Service Bulletin

Category T	Applicable Model/s 1995 Millenia	Subject BATTERY DISCHARGE FROM TRUNK LIGHT STAYING ON	Bulletin No. 002/94
			Issued 6/21/94
			Revised

1995 Millenia vehicles with a VIN of JM1TA22**S100001 through JM1TA22**S101809

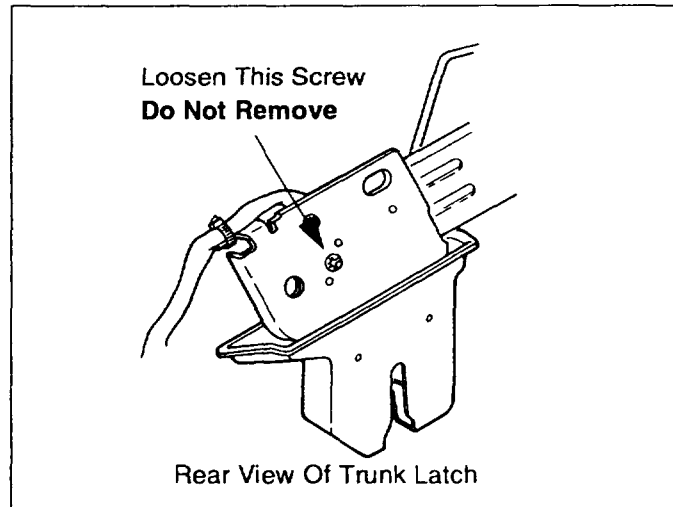
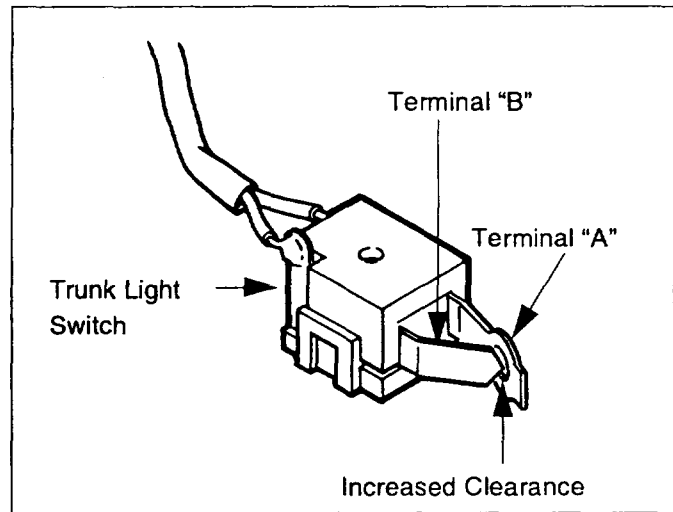
Some vehicles may have discharged batteries caused by the trunk light staying on after the trunk lid is closed. This is caused by incorrect installation of the trunk light switch.

To correct this problem, the clearance between terminals "A" and "B" has been increased.

Customer and inventory vehicles which have battery drain problems should have the trunk light switch inspected and repaired according to the instructions in this bulletin.

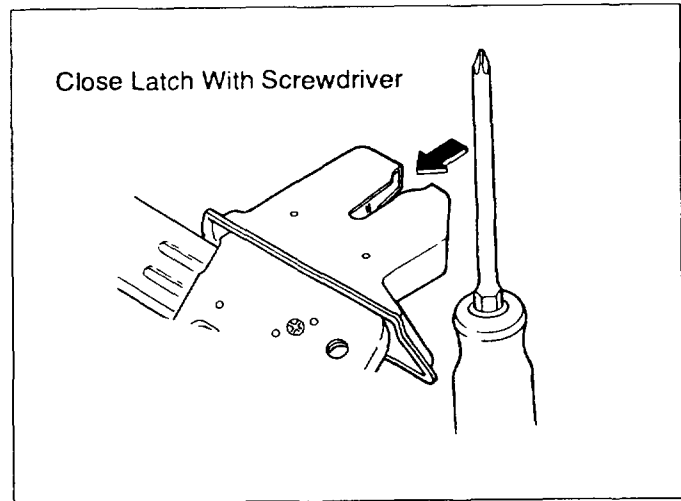
3. Close the trunk lid latch with a screw driver.

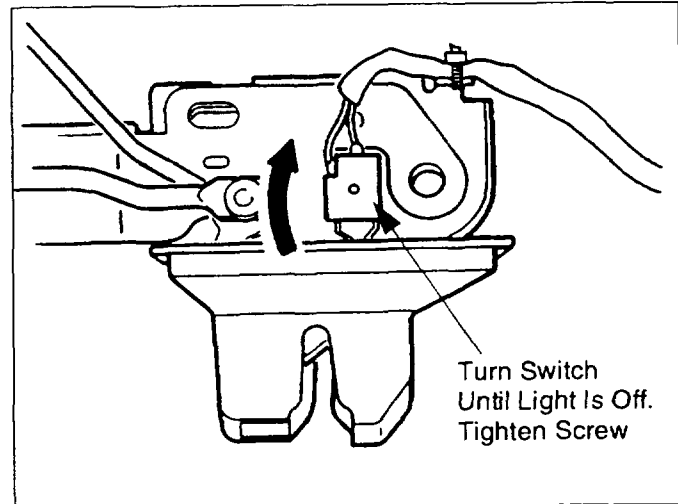
4. Adjust the switch by turning the switch body until the light is off.

NOTE: If the switch terminals are bent, straighten prior to adjustment.
